Docket Number:	12-AFC-03
Project Title:	Redondo Beach Energy Project
TN #:	200250
Document Title:	Joanna Edwards Comments: Stop New AES Redondo Power Plant
Description:	N/A
Filer:	System
Organization:	Joanna Edwards
Submitter Role:	Public
Submission Date:	8/20/2013 12:05:41 PM
Docketed Date:	8/20/2013

Stop New AES Redondo Power Plant

**Study of an Environmentally Superior Alternative to
Proposed New Generation at the Redondo Beach Generating
Station for Meeting Local Capacity Requirements in the
Western LA Basin Sub-Area**

Figure 1. Current Redondo Beach Substation Configuration

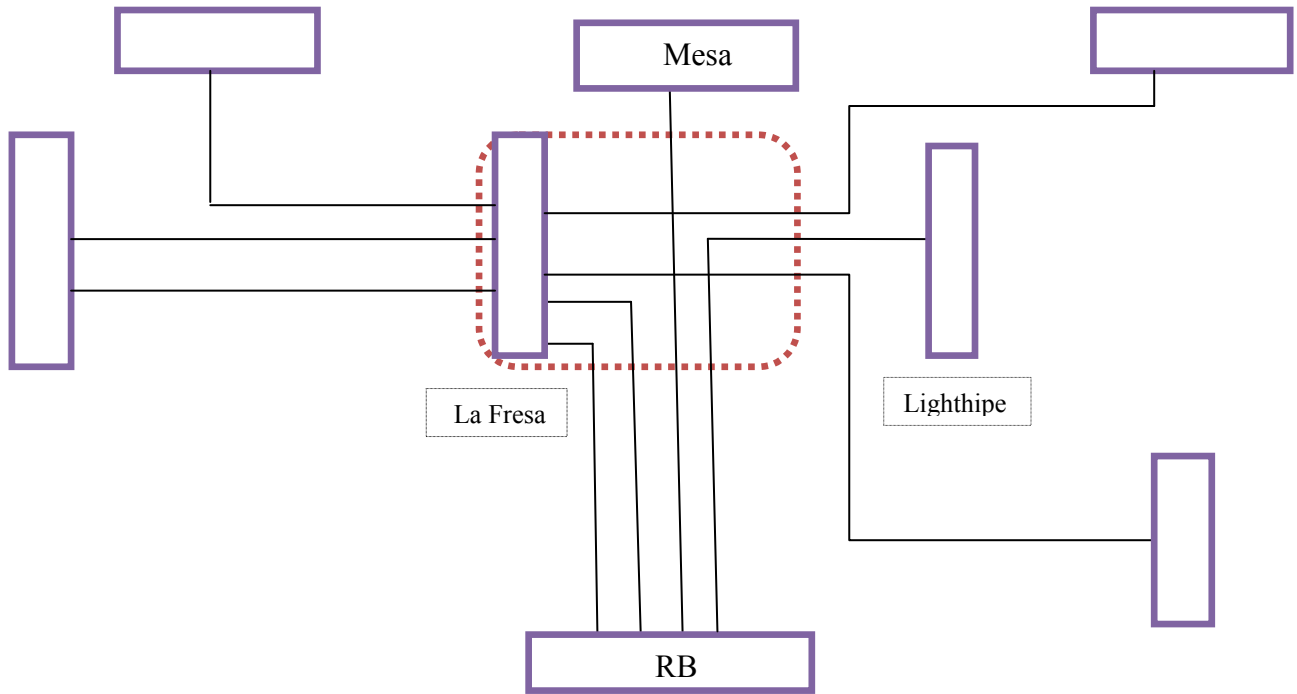
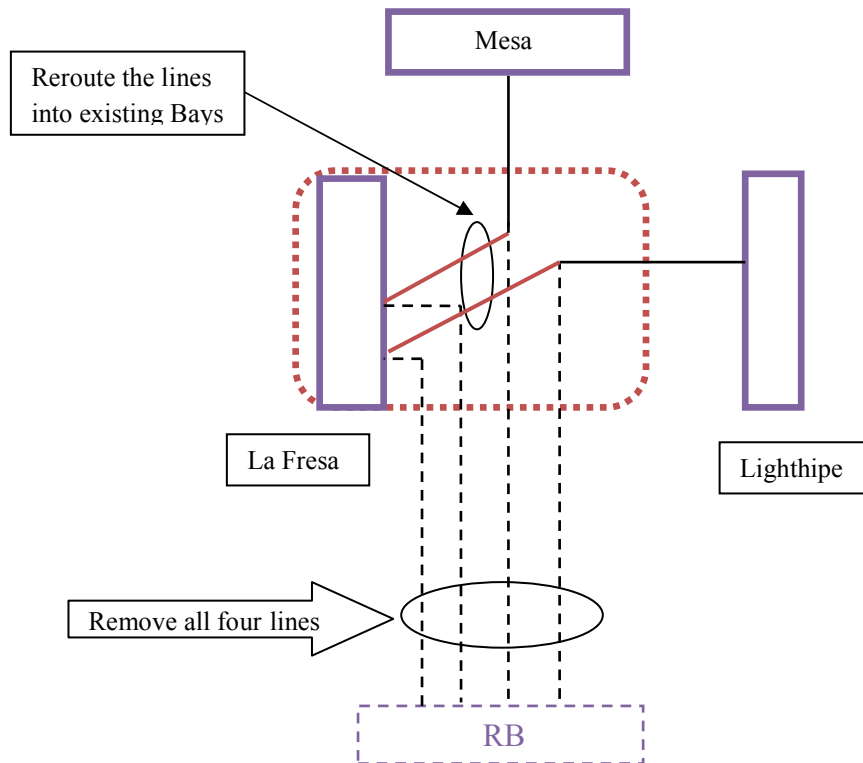
When the existing generating units are retired the associated step-up transformers can be removed as they would serve no purpose. What remains at the Redondo Beach facility will be the Redondo Beach 230 kV substation. The Redondo Beach 230 kV substation is connected to the transmission grid by four 230 kV transmission lines. The existing connections are shown schematically in Figure 1 below.

Advanced Energy Solutions' investigation found that a relatively simple transmission system reconfiguration at La Fresa substation will allow the existing Redondo Beach 230 kV substation, and all four transmission lines between the existing Redondo Beach 230 kV substation and the existing La Fresa substation, to be removed. The removal of these facilities presents a unique opportunity to restore the entire Redondo Beach power plant site, as well as the existing transmission corridor between the Redondo Beach 230 kV substation and the La Fresa substation, to beneficial public use. Such restoration offers the potential for significant environmental benefits.

1. Remove the existing 230 kV Redondo Beach-La Fresa #1 and #2 lines, leaving the existing breakers and disconnect switches and two open bay positions at the La Fresa 230 kV bus,
2. Disconnect the existing 230 kV Redondo Beach-Mesa line and the existing 230 kV Redondo Beach-Laguna Bell line within the La Fresa substation perimeter, and
3. Tie the disconnected 230 kV Redondo Beach-Mesa line and the disconnected 230 kV Redondo Beach-Laguna Bell line to the La Fresa 230 kV bus using the two open bay positions that are made available by the removal of the 230 kV Redondo Beach-La Fresa #1 and #2 lines.³⁶

When this transmission system reconfiguration is implemented, the existing Redondo Beach 230 kV substation, and all four 230 kV transmission lines between the existing Redondo Beach 230 kV substation and the existing La Fresa substation, can be removed. The resulting transmission configuration is shown schematically in Figure 2 below. Note that this reconfiguration requires virtually no new infrastructure since all four of the existing 230 kV transmission lines that connect the Redondo Beach 230 kV substation to the existing transmission system terminate within, or pass through, the perimeter of the existing La Fresa substation. Further, because there would be no generation at the Redondo Beach site, fault duty on the existing circuit breakers should be reduced thereby obviating any need to replace breakers when the new configuration is implemented.
